10/518,490

**Office Action Summary**

DETAILED ACTION

**FIG. 1**

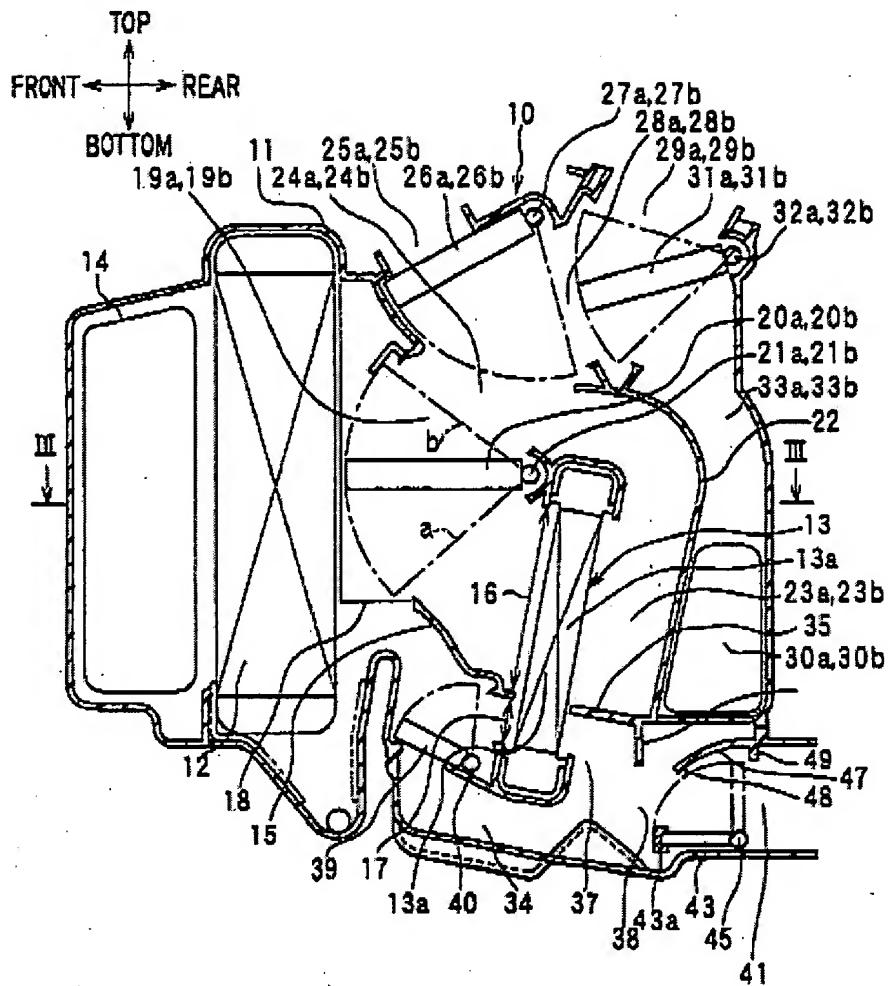
3. In re claim 1, Derleth et al '082 discloses a heating and/or air conditioning system for a motor vehicle, having a housing (10), the housing being composed of a plurality of housing segments (see figs. 1 and 5), characterized in that at least one housing segment is designed as an insert part (11, fig. 5), the insert part (11, fig. 5) being inserted into the remaining housing only after the remaining housing is installed in the motor vehicle, and the insert part (11, fig. 5) comprising at least one functional subassembly (43-45, fig. 5).

4. In re claim 2, Derleth et al '082 discloses invention above and further discloses that the functional subassembly (43-45, fig. 5) comprises at least one air-guiding means (41).

**FIG. 5**

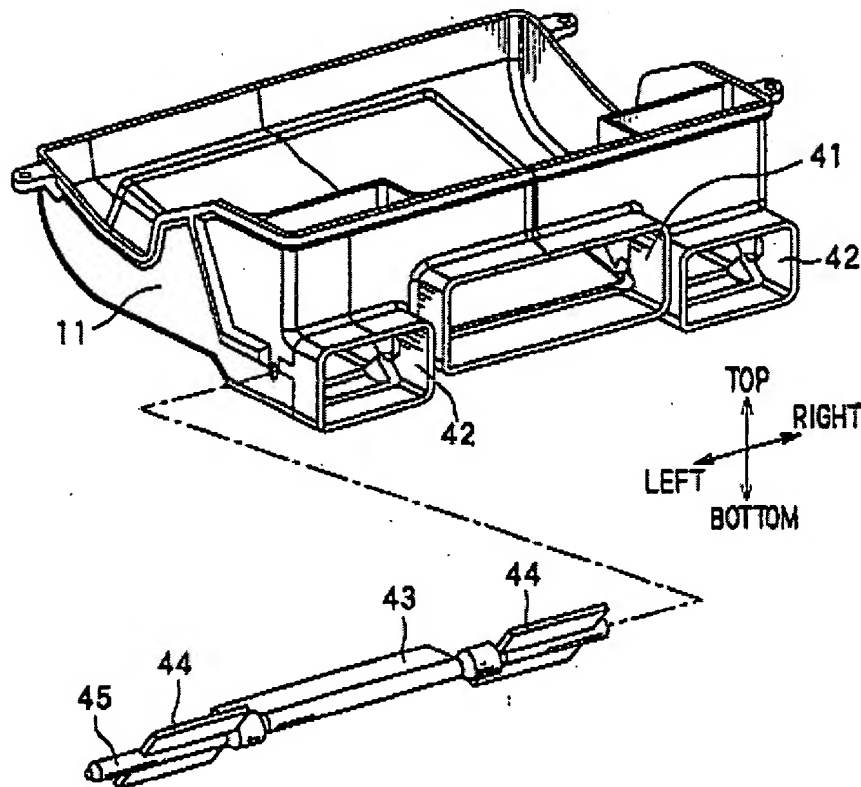
3. In re claim 3, Derleth et al '082 discloses invention above and further discloses that the functional subassembly is a mixing module (24) for a rear region.

4. In re claim 4, Derleth et al '082 discloses invention above and further discloses that the functional subassembly (43-45, fig. 5) comprises a hot air supply (13) and/or a cold air supply (12).

5. In re claim 5, Derleth et al '082 discloses invention above and further discloses that the functional subassembly (43-45, fig. 5) comprises at least one mixing flap (44).

6. In re claim 6, Derleth et al '082 discloses invention above and further discloses that the functional subassembly comprises at least one drive (**REFERENCE A**) for the at least one mixing flap (44).

7. In re claim 7, Derleth et al '082 discloses invention above and further discloses that the insert part (11, fig. 5) is formed symmetrically with respect to a longitudinal axis (L).

8. In re claim 8, Derleth et al '082 discloses invention above and further discloses that the functional subassembly (43-45, fig. 5) is a mixing module (24) for a rear region.
